Notice of Project Change to the Air Rights Garage EEA #8505
and Waterside Place EEA #13367

South Boston Waterfront Transportation Center

**Re: South Boston Waterfront Transportation Center
Notice of Project Change to Air Rights Garage (EEA #8505) and Waterside Place (EEA #13367)**

Figure 5
Waterside Place Project
Construction Phasing
**South Boston Waterfront Transportation Center
Boston, Massachusetts**

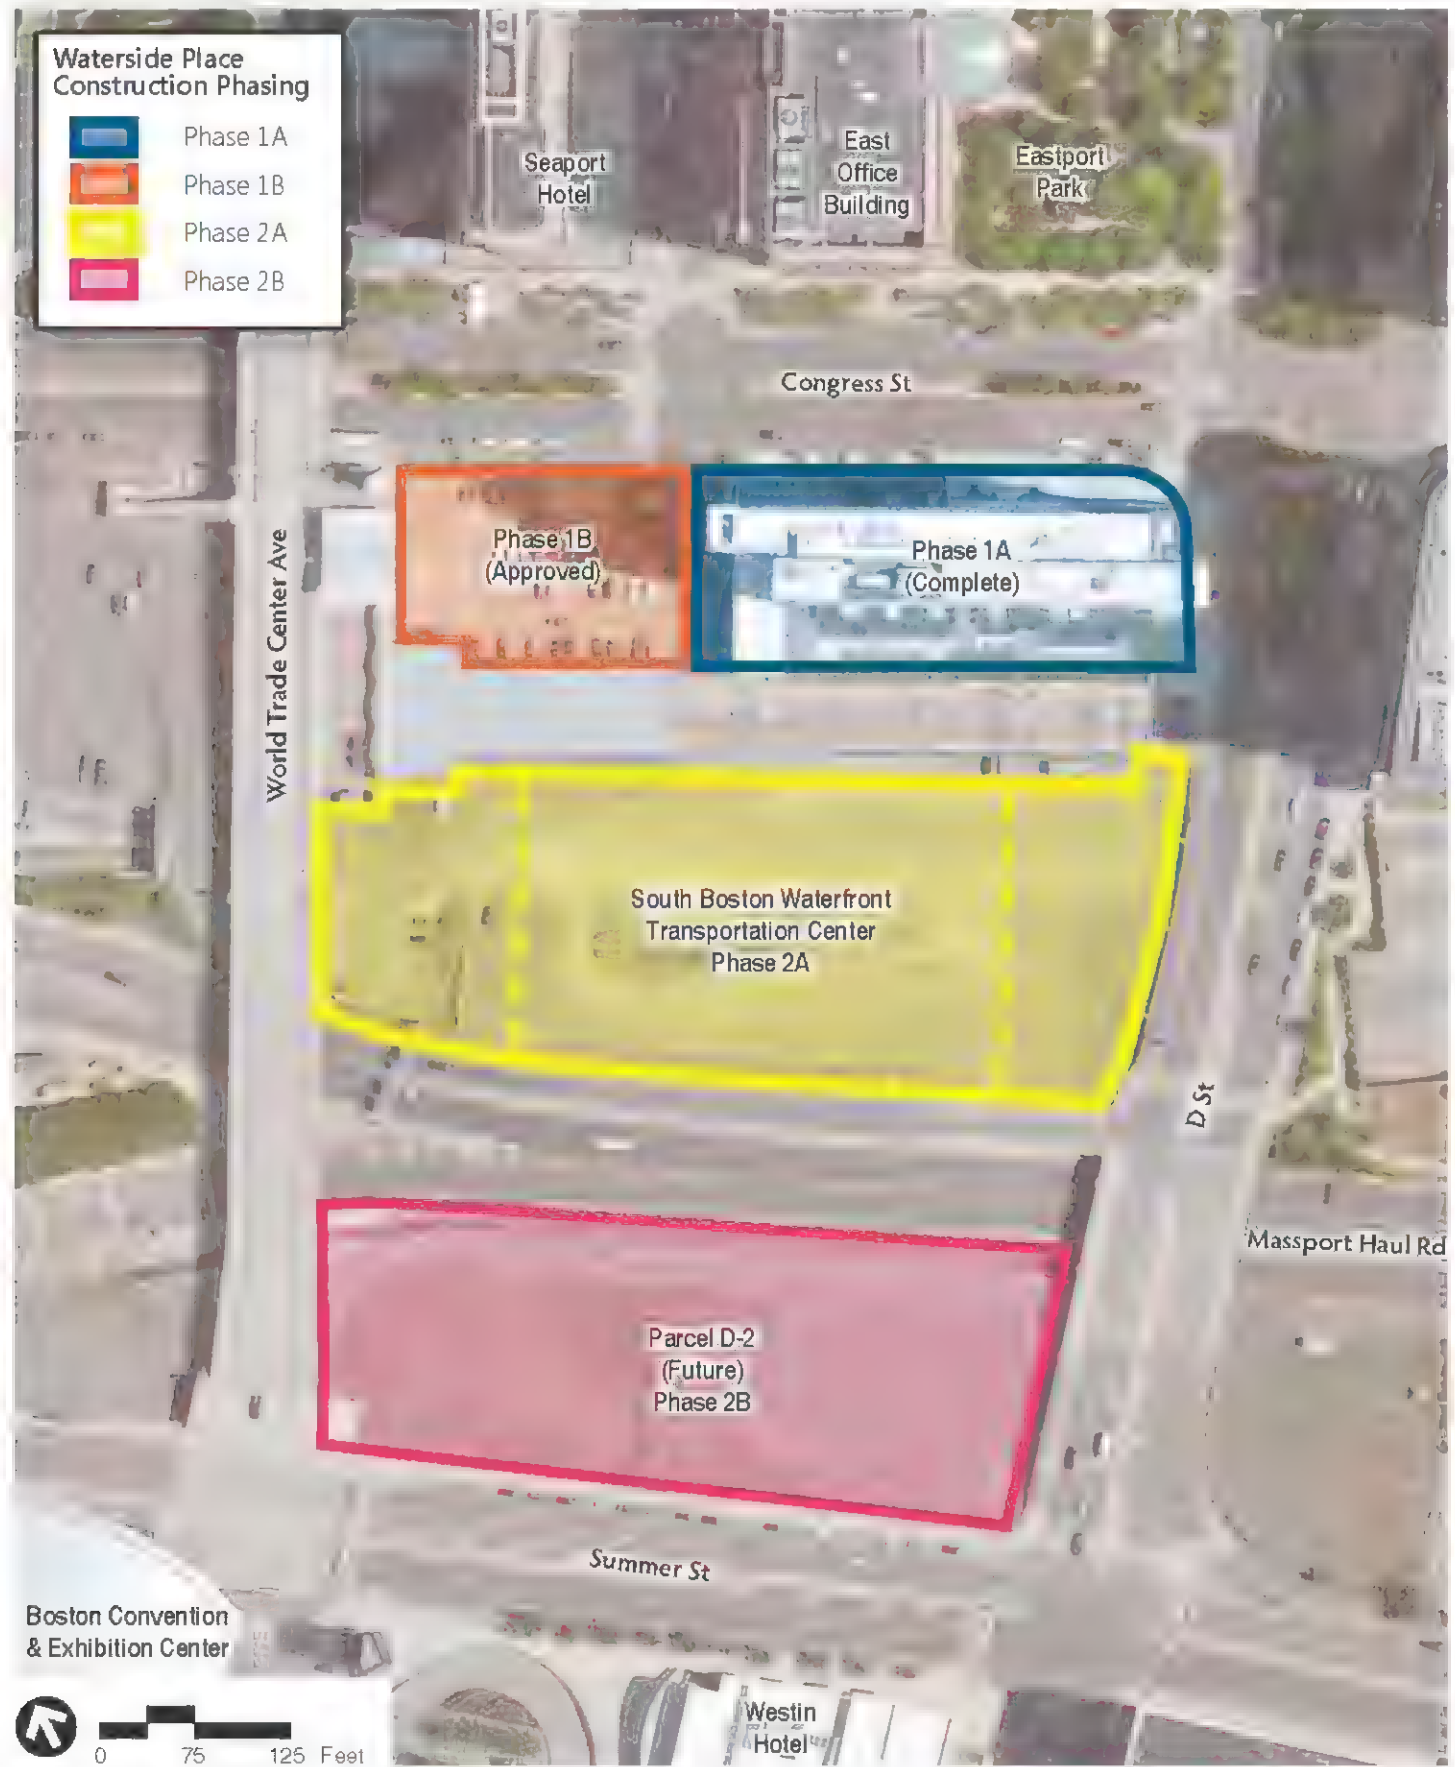
As depicted in Figure 5, the material changes to the project as previously reviewed, and the subject of this review, include:

The current phasing for Waterside Place is shown in **Figure 5, Waterside Place Project Construction Phasing**.

Public Realm Enhancement Concept Plan

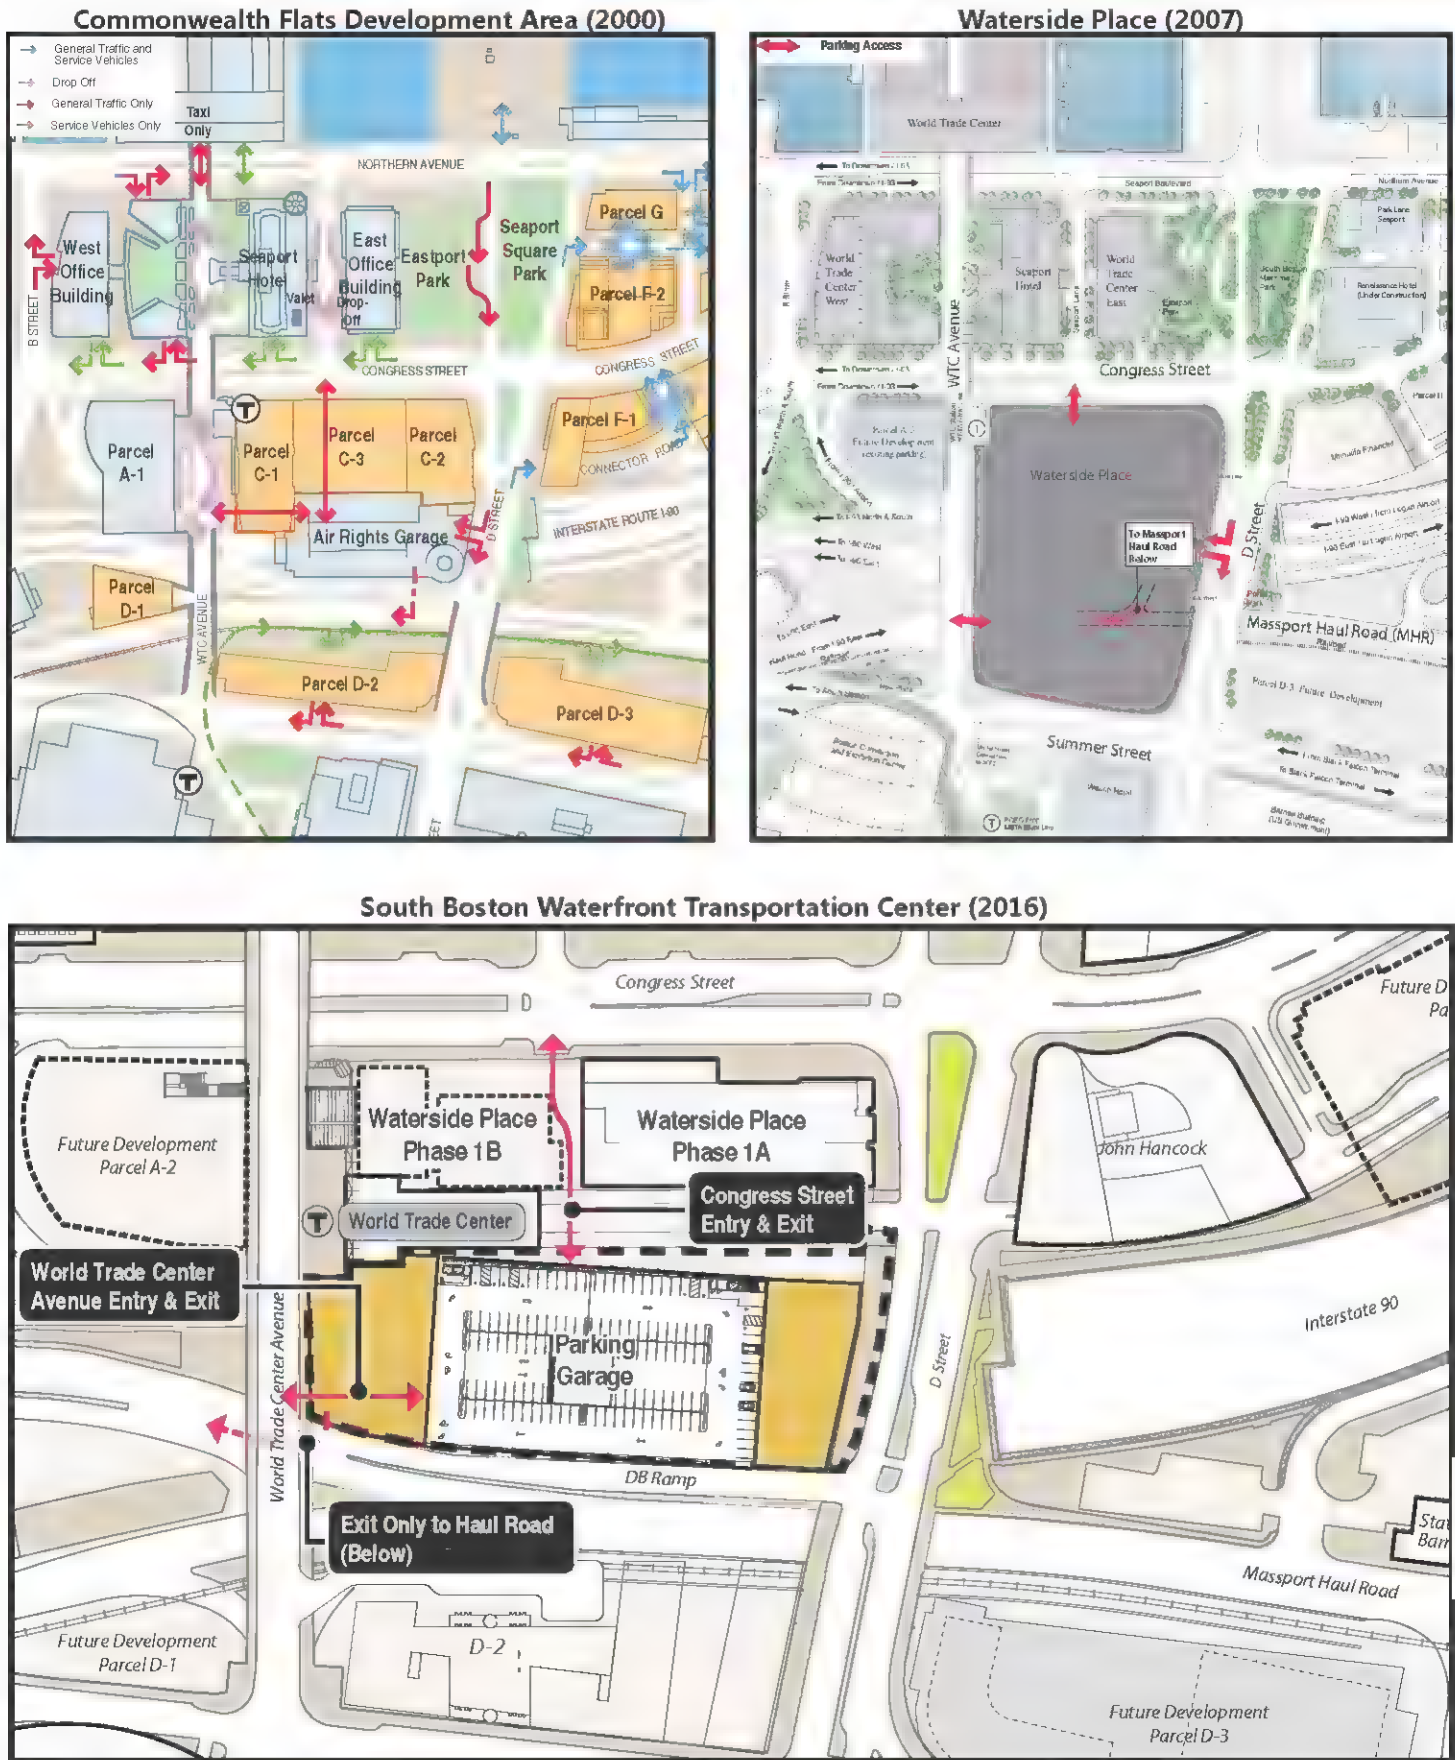
The program of the facility will also provide and will contribute to several public realm improvements to enhance pedestrian connections, as illustrated in **Figure 6, Public Realm Enhancement Concept Plan**. These strengthened pedestrian connections include ■ covered walkway connection towards the adjacent MBTA Silver Line station and other key district destinations along WTC Avenue. The WTC mobility and pedestrian plaza located between the parking facility and WTC Avenue will enhance connectivity to the adjacent Silver Line station.

The mobility plaza along WTC Avenue (see **Figure 6**), measuring approximately 25,000 square feet, includes a covered walkway from the Silver Line T station headhouse across the plaza, which ultimately connects via WTC Avenue to Summer Street and north to the waterfront and water transportation options. The mobility plaza will include ■ single-story pedestrian oriented pavilion, with mobility features such as real-time modal availability and schedule information, interactive kiosks and bicycle parking. The Plaza could also accommodate more recreation-oriented transportation functions such as pedi-cabs.
